Three Mile Island Nuclear Station, Unit 1
Renewed Facility Operating License No. DPR-50
NRC Docket No. 50-289

Subject: Third Six-Month Status Report in Response to March 12, 2012 Commission Order Modifying Licenses with Regard to Reliable Spent Fuel Pool Instrumentation (Order Number EA-12-051)

**Third Six-Month Status Report for the Implementation of Order EA-12-051, Order
Modifying Licenses with Regard to Reliable Spent Fuel Pool Instrumentation**

ATTACHMENT 1 - TMI-1 SPENT FUEL POOL ELEVATION SKETCH

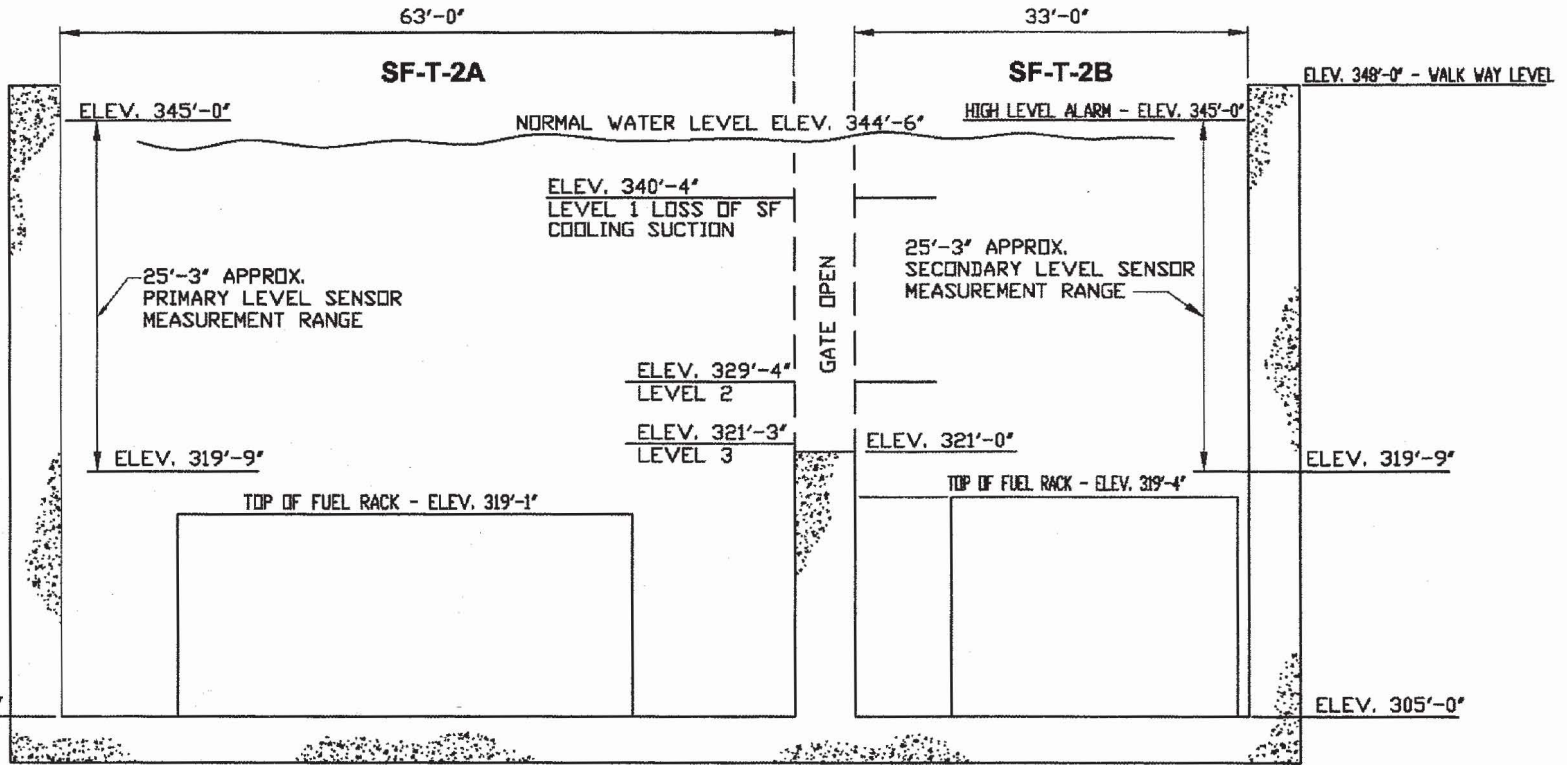
Draft Safety Evaluation Open Items		
OI#	Description	Status
1 (RAI-2 Ref 5)	RAI Question: Please describe the impact of the installation of the gate on the reliability of the SFP level instrumentation for each SFP, and what compensatory measures would be taken to ensure reliable level indication in each SFP when the gate is installed.	<u>Complete</u> Complete redundant monitoring of the pools will not be available when the gate is installed. The gate is not normally installed. There is an existing procedure 1507-2, Fuel Handling Building Crane Operations, which installs and removes the gate. To address the concern when the gate may be installed the procedure 1507-2 will be revised to establish administrative guidance/controls to follow the NEI 12-02 Rev. 1 section 4.3 guidance for the 90-day out of service criterion. Action will be tracked by AR evaluation A2322479-08. The elevation for the bottom of the gate opening for TMI is 321ft. Level 3 for TMI is revised to elevation 321ft. 3 in., which is slightly above the bottom of the gate opening, rather than, the top of the Fuel rack elevation 319ft. 1 in. This will provide assurance that both the primary and backup SFP level instrument channels can measure the same Level 3 elevation in both SFPs. See revised Attachment 1.
